COOPER NUCLEAR STATION

AMENDMENT TO FACILITY OPERATING LICENSE

Amendment No. 16
License No. DPR-46

ATTACHMENT TO LICENSE AMENDMENT NO. 16
CHANGE NO. 19 TO THE TECHNICAL SPECIFICATIONS
FACILITY OPERATING LICENSE NO. DPR-46
DOCKET NO. 50-298

Figure 3.11-1.1. Maximum Average Linear Heat Generation Rate versus Planar Average Exposure, Initial Core, Fuel Types I and III.

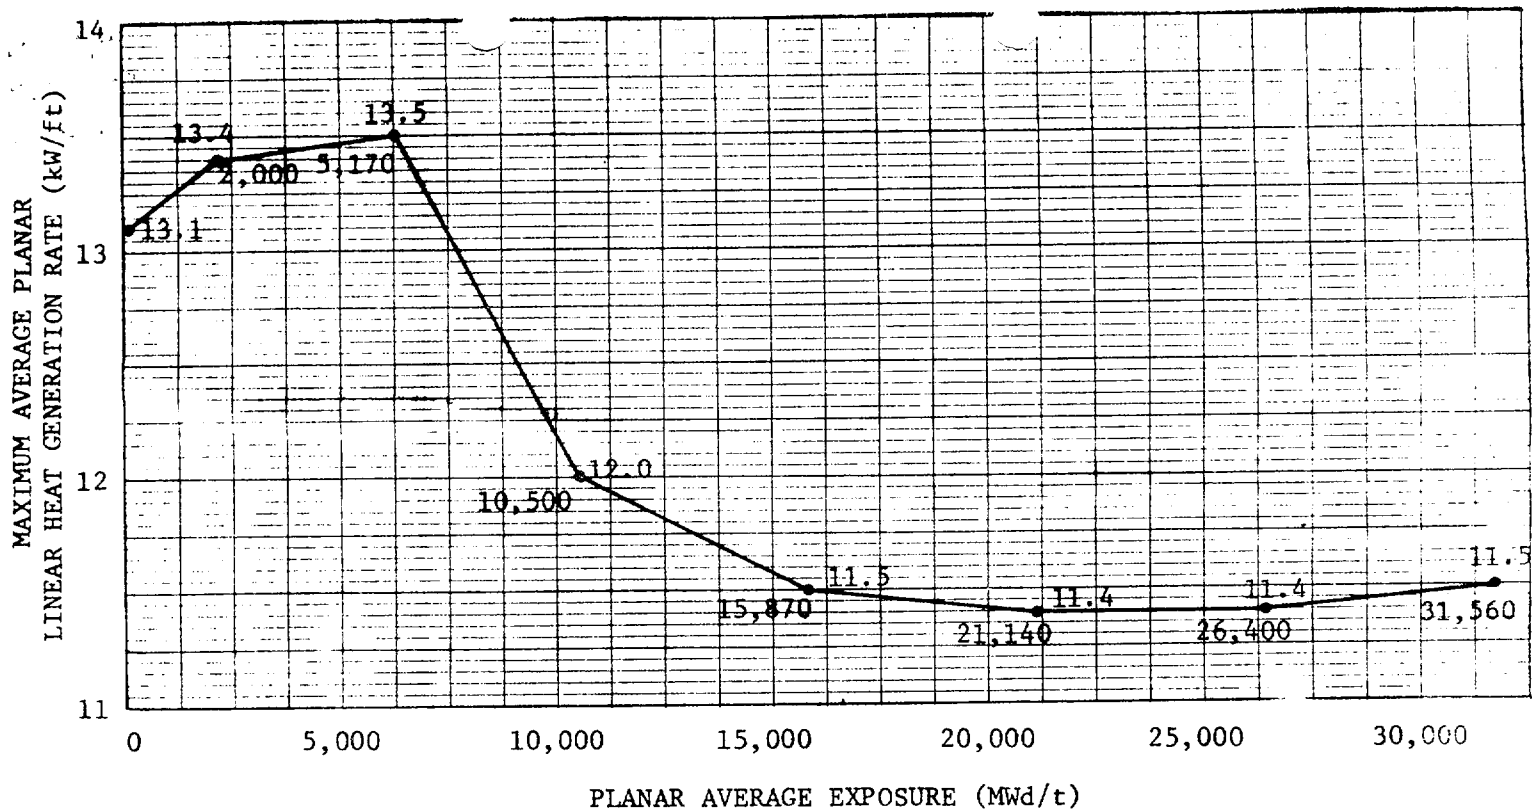
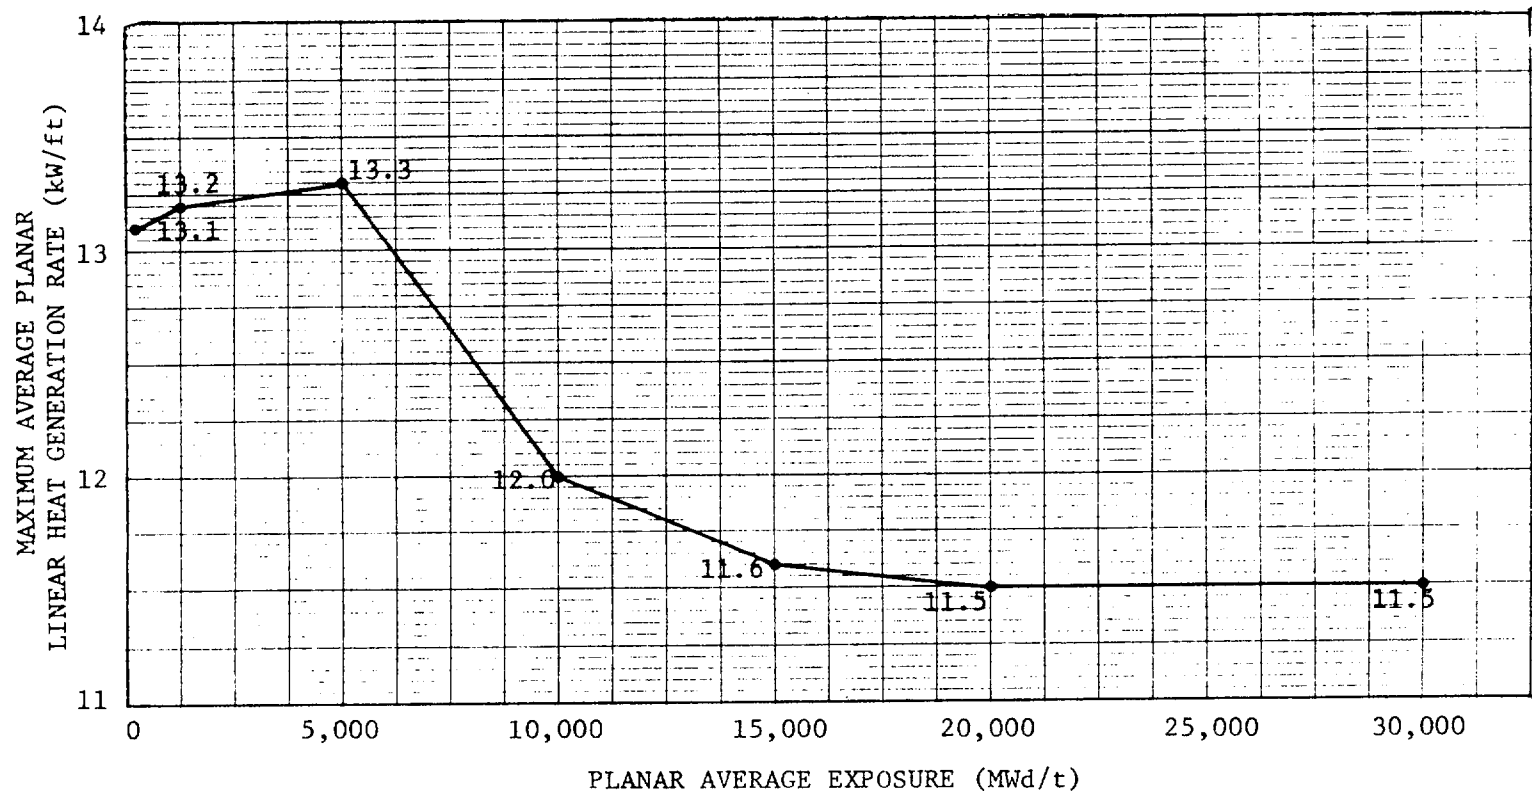
During steady state power operation, the APLHGR for each type of fuel as a function of average planar exposure shall not exceed the limiting value shown in Figure 3.11-1. If at any time during steady state operation it is determined by normal surveillance that the limiting value for APLHGR is being exceeded action shall then be initiated to restore operation to within the prescribed limits. Surveillance and corresponding action shall continue until the prescribed limits are again being met.

The average planar linear heat generation limits would be revised to be consistent with the analyses performed in accordance with 10 CFR 50.46 for operation with plugged bypass holes in the lower core plate.

FIGURE 3.11-2

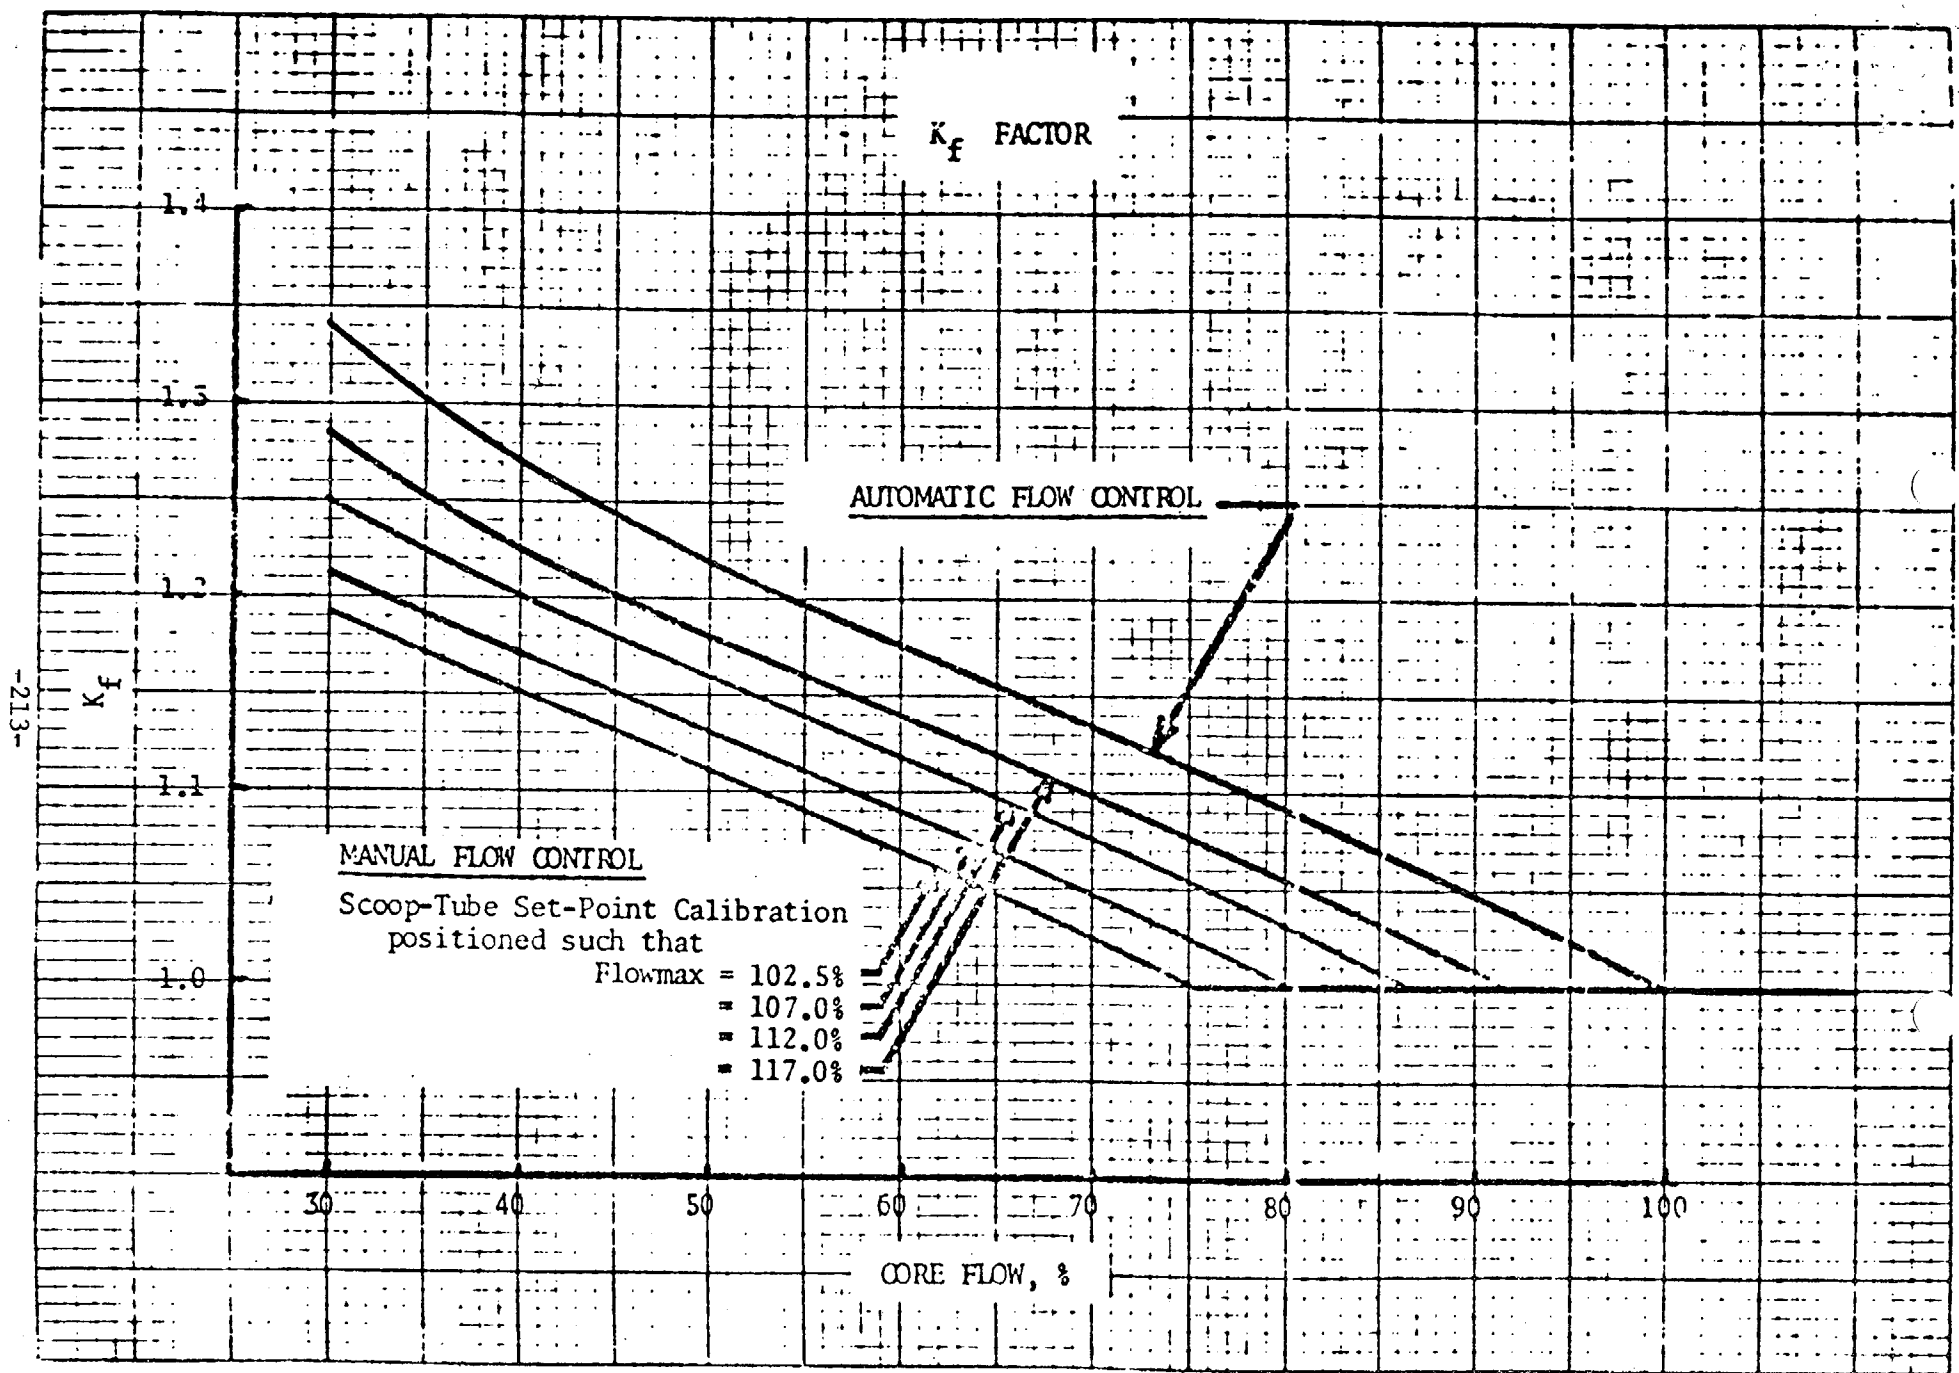
For core flows other than rated the MCPR shall be > 1.29 for 7x7 fuel and $<$ (TBS) for 8x8 fuel times K_f , where K_f is as shown in Figure 3.11-2.

The K_f factor curves shown in Figure 3.11-2 were developed generically which are applicable to all BWR/2, BWR/3, and BWR/4 reactors. The K_f factors were derived using the flow control line corresponding to rated thermal power at rated core flow.

The K_f factors shown in Figure 3.11-2, are conservative for Cooper operation because the operating limit MCPR of 1.29 is greater than the original 1.20 operating limit MCPR used for the generic derivation of K_f .
